**140-148 DENISON STREET AND 25-49 SMITH STREET, HILLSDALE
JOINT REGIONAL PLANNING PANEL NO. 2012SYE009
PROPOSED BUNNINGS DEVELOPMENT (COUNCIL REF. DA 11/224))
APPLICANT REQUEST FOR AMENDMENT TO DRAFT CONDITIONS &
RESPONSE TO COUNCIL SUPPLEMENTARY REPORT**

***Attachment 1: TABLE OF PROPOSED AMENDMENTS TO "DRAFT WITHOUT
PREJUDICE CONDITIONS FOR JOINT REGIONAL PLANNING PANEL" - DA 11/224***

condition for section 94 contributions.
(extracts of Drawings DA203 and DA204 are shown on the following page)

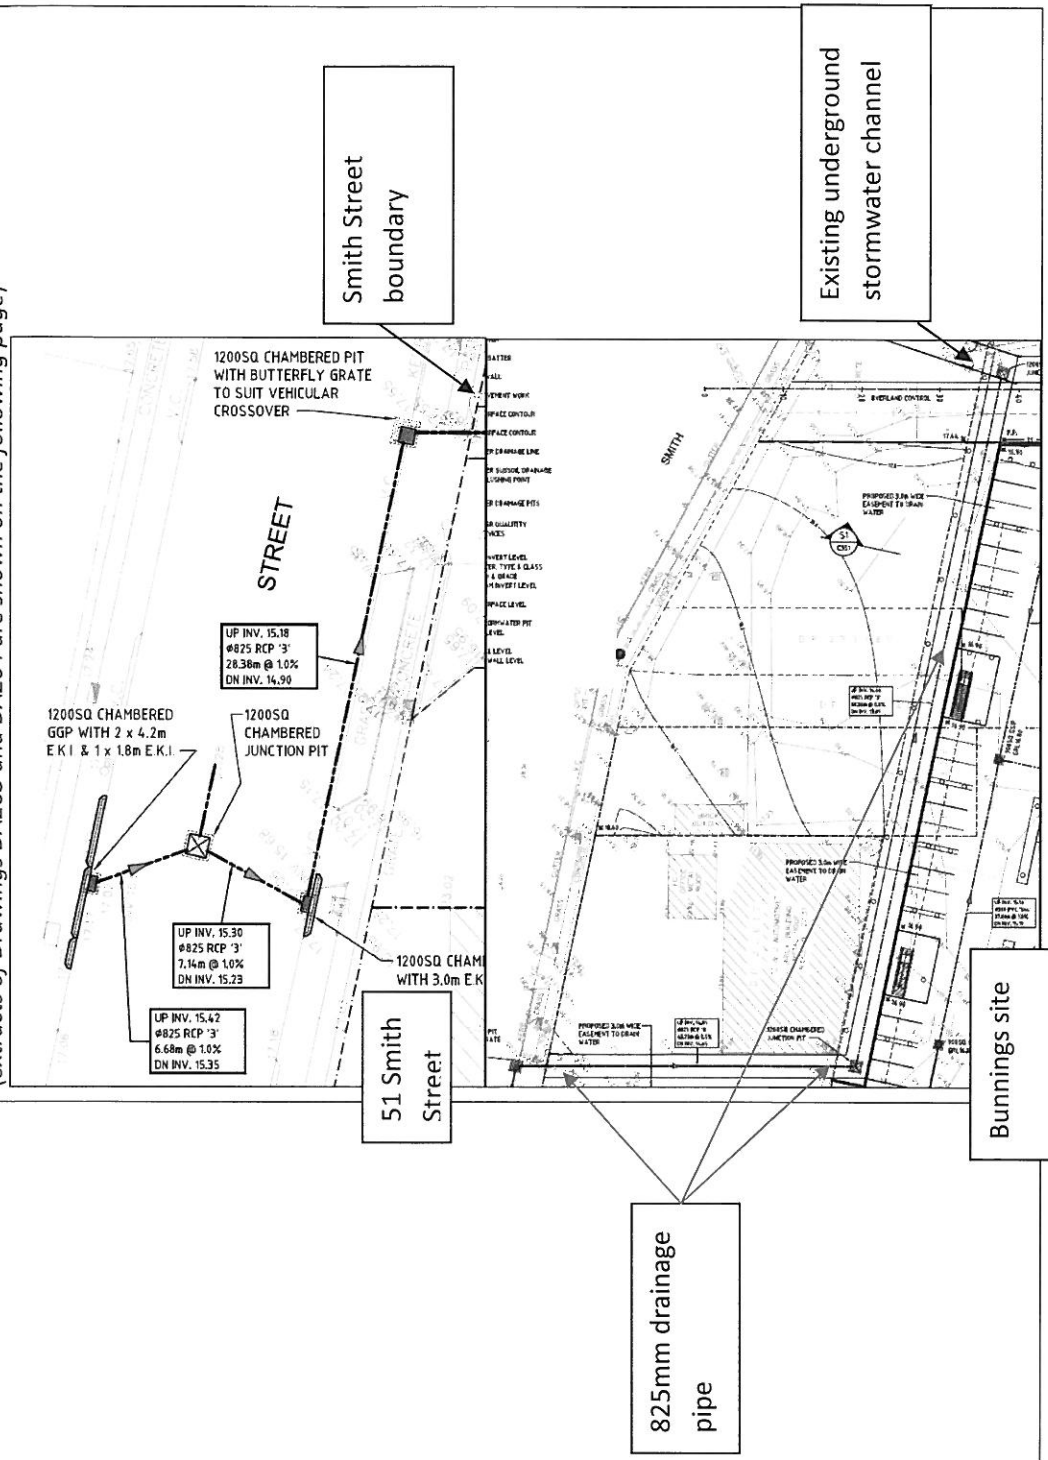
No.	Current condition	Proposed Change & Justification
		4. Two development consents have been issued on this site and contributions levied pursuant to the same section 94 plan; being DA08/126 (approved 6/11/08) and DA 05/258. In both cases the applicable section 94 assessment considered and accepted a "credit" to the equivalent of 14,470m² of GFA which reflected the long standing prior factory use of the site. In terms of Table 8.2 of the Section 94 plan this equates to a credit of 200 employees. A fair application of the principles applicable to those developments, pursuant to the same section 94 plan, indicates the Bunnings development on this site should similarly be eligible for the credit for previous development. 5. Applying the workforce density of Table 8.2 of the section 94 Plan to the proposed GFA for the Bunnings development (14,920m²), and applying a Showroom rate of 85.1m²/employee, yields an employee number for the purposes of the section 94 plan of 175 for the Bunnings development. (I note the section 94 plan's employee density of 85.1m²/100m² GFA is higher than other Bunnings Warehouses wherein the average employee density is closer to 1/100m² GFA.) 6. Council officers brought a local infrastructure issue, being a drainage "sag" in Smith Street, to Bunnings attention during the DA assessment process. At officer's suggestion Bunnings included in its DA documentation a proposal for drainage works which provide a "Material Public Benefit". This work will occur to the north and uphill of No.s 51-55 Smith Street. Notwithstanding the fact rectification of this local flooding issue is not in any section 94 plan, Bunnings have depicted these works in the civil engineering drawings (DA203 and DA 204) submitted with this DA, and comprise in summary: (i) Kerb inlets and chambers on both sides of Smith Street, (ii) 6 junction pits (iii) A total of 175 metres of 825mm diameter RCP under Smith Street, entering the site and eventually linking street drainage to the existing Sydney Water pipes (iv) Provision of an easement in favour of Council across the Bunnings site to cover the new public drainage system 7. A conservative estimate of the value of these drainage works (exclusive of easement costs) would exceed \$120,000. 8. We consider that the foregoing information warrants no imposition of a Section 94 contribution for this development at all. In the alternative, we consider that the circumstances of the case and the terms of Section 94(5)(b) of the <i>Environmental Planning & Assessment Act 1979</i>, enables the consent authority to accept that the material public benefit offered in this development, is accepted in full satisfaction of a
